TRANS/WP.29/GRSP/2003/2
21 March 2003

PROPOSAL FOR DRAFT AMENDMENTS TO REGULATION No. 14
(Safety-belt anchorages)

Transmitted by the Expert from International Organization of
Motor Vehicle Manufacturers (OICA)

Figure 2

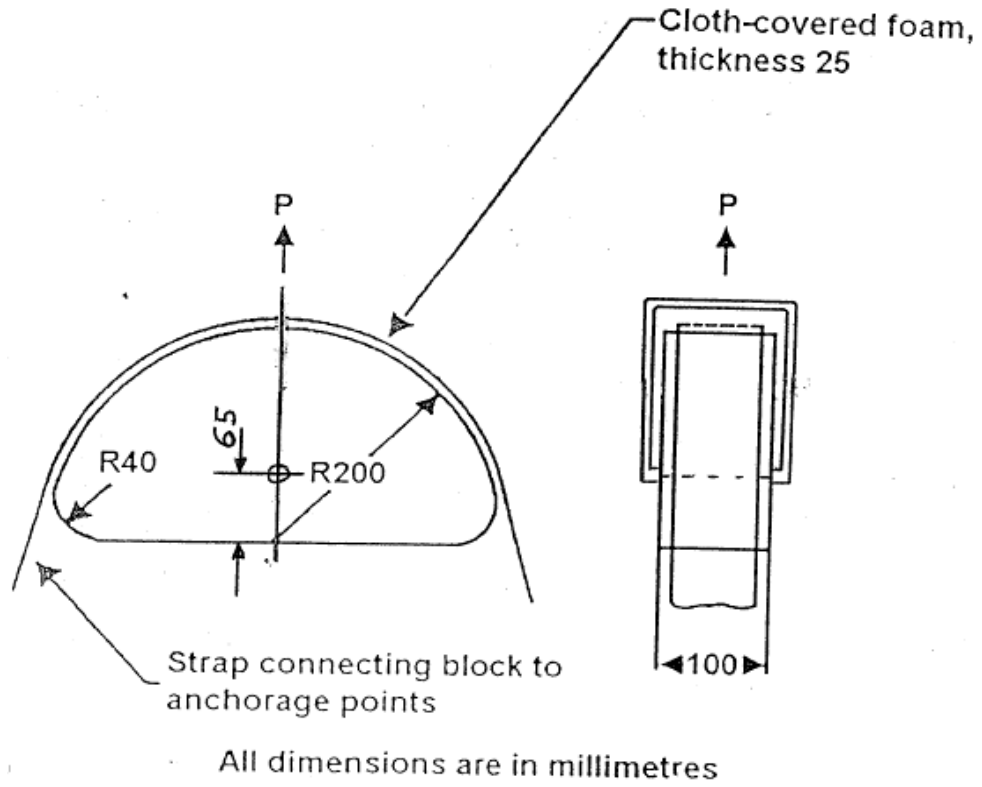
“6.3.4. Traction devices to be used in the tests described in paragraph 6.4 below are shown in annex 5. **The devices shown in annex 5, figure 1 are placed onto the seat cushion and then pushed back into the seat back while the belt strap is pulled tight around it. The device shown in annex 5, figure 2 is placed in position, the belt strap is fitted over the device and pulled tight. The arrangement of the devices is shown in annex 5 figures 4 and 5.**”

Figure 2, amend to read:

Note: The 65 mm dimension proposed for annex 5 figure 2 was shown in the SAE Handbook.

FIGURE 4

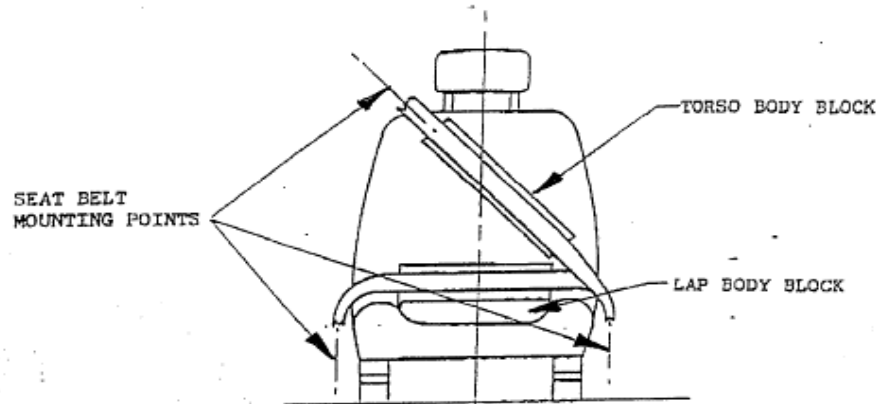
Add new figures 4 and 5, to read:
